Project Name: Euston One

Sub-catchment addressed by this Addendum: 35 – 37 William Road

Note Title: Flood Risk Assessment Addendum No.1

Date: 19th May 2021 (1st Issue)

| Appendix D — Revised Site Drainage F | Plan | |

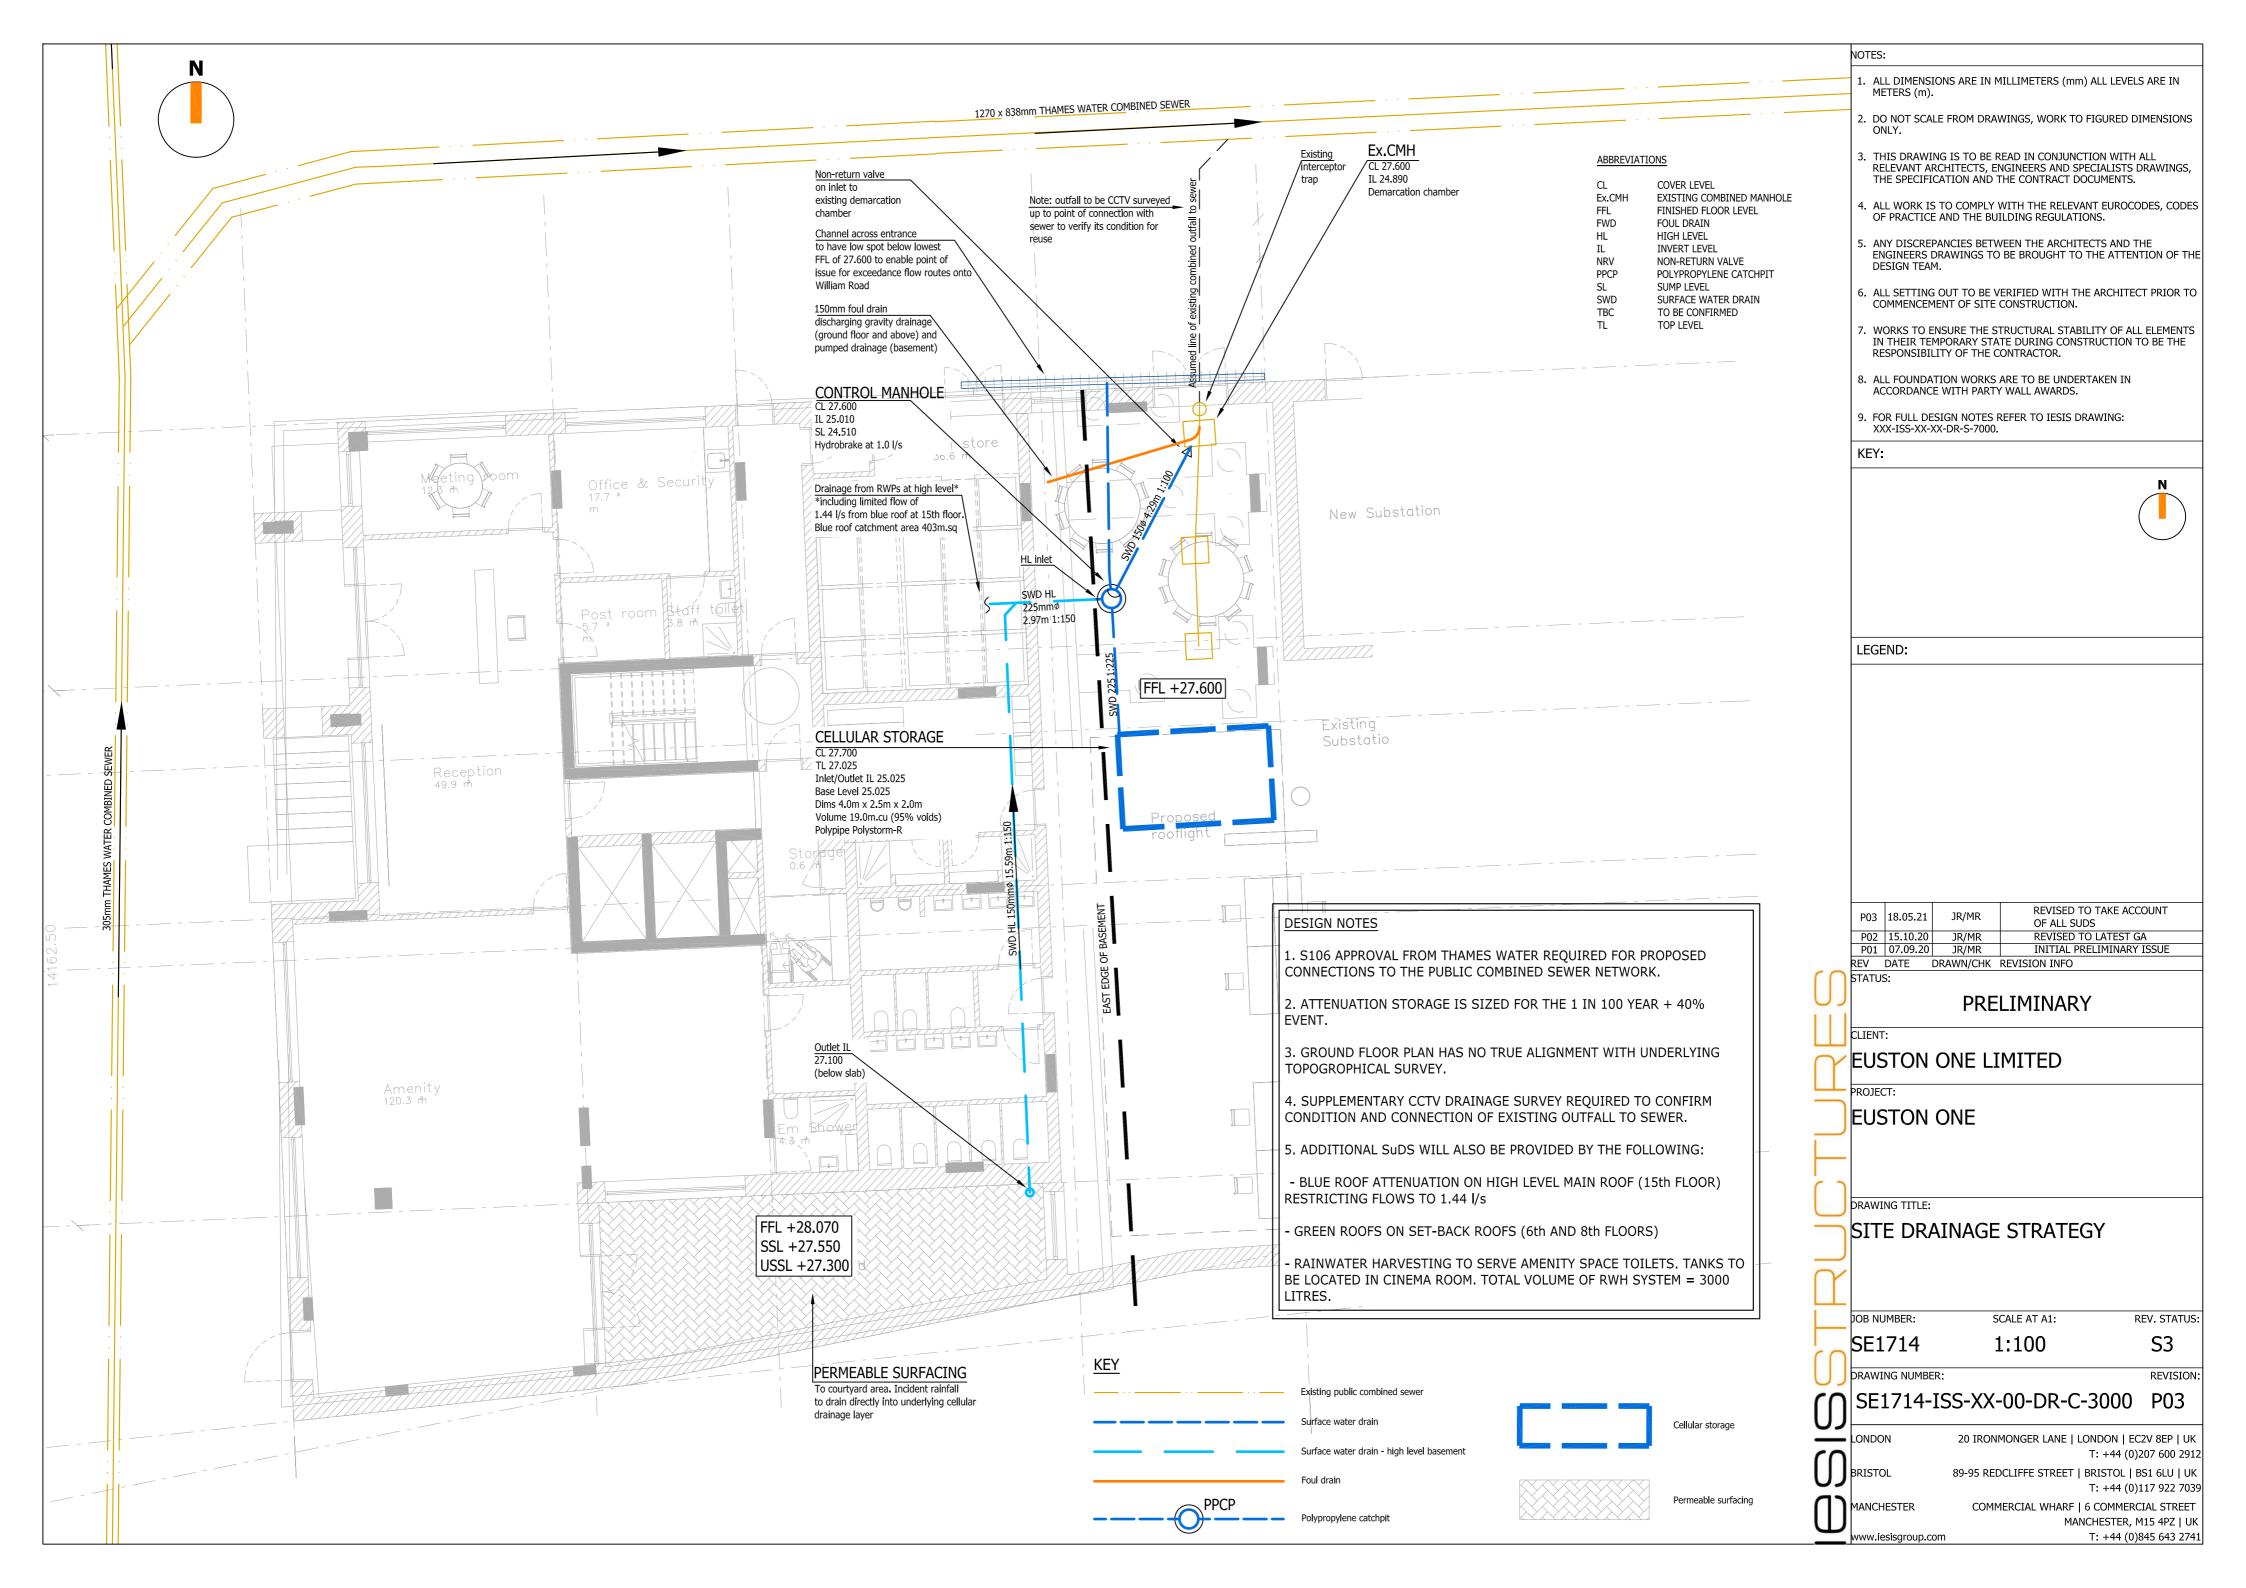
- 2.10 "Confirmation that gravity discharge from the attenuation tank to the public sewer is feasible": we confirm that gravity discharge to the sewer from the attenuation tank is feasible as shown on the Site Drainage Strategy drawing in Appendix D. The base of the tank will sit at level +25.025, which is 135mm above the existing boundary manhole invert level of +24.890 (reference "Ex.CMH"), which itself drains to the sewer in William Road by gravity.

| Appendix E – Blue Roof Attenuation & Outflow Calculation | | | | |

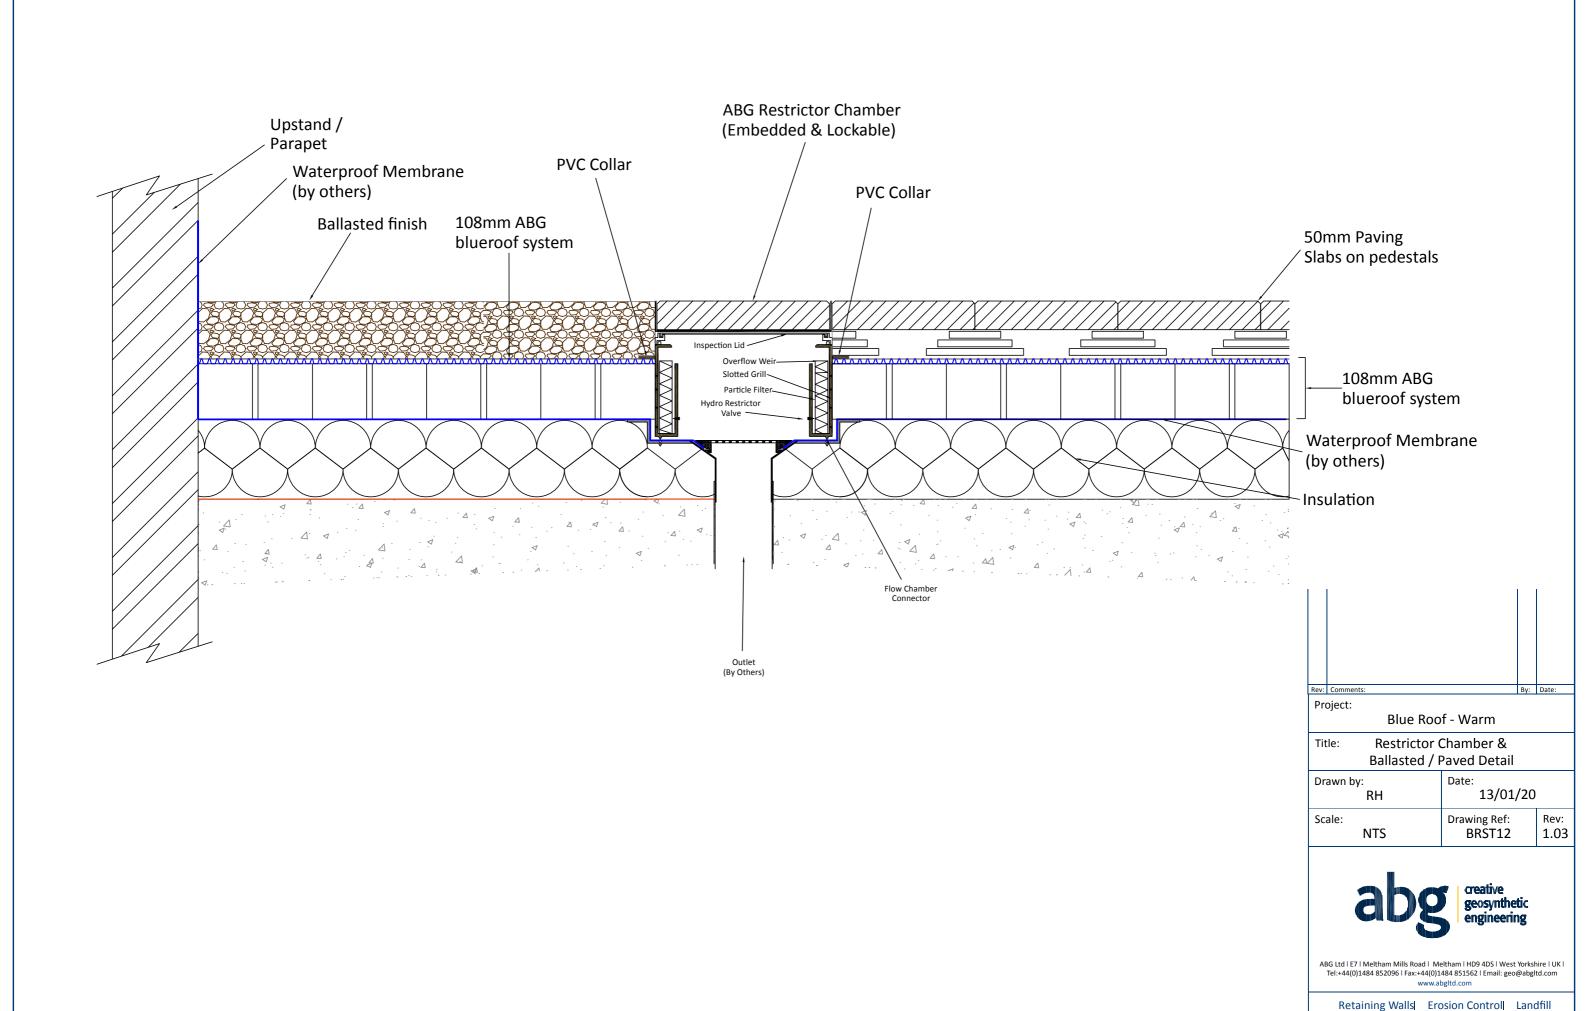
- 2.5 "Details of flow routes for exceedance events": refer to Exceedance Flow Routes plan in Appendix C.
- 2.6 "Viability of blue roof attenuation required": the incorporation of a blue roof into the design has been considered. It is proposed to implement blue roof attenuation on the main high-level roof (15th floor, catchment area 403m²) using a 108mm Aquamodul blue roof system by Axter. This will restrict the outflow from the roof to a maximum of 1.44 l/s and will provide approximately 38m.cu of attenuation storage (0.108m x 351m.sq attenuation area = 37.9m.cu). This will reduce the quantity of below ground storage by 50% compared to the strategy within the originally submitted FRA, from 38m³ to 19m³. For calculations pertaining to the blue roof system, revised Drainage Strategy Drawing and supporting Micro Drainage outputs refer to Appendices D, E & F.

Total attenuation required: 33.80 m³

Total attenuation capacity: 34 m³

Number of Blue Roof outlets: 3
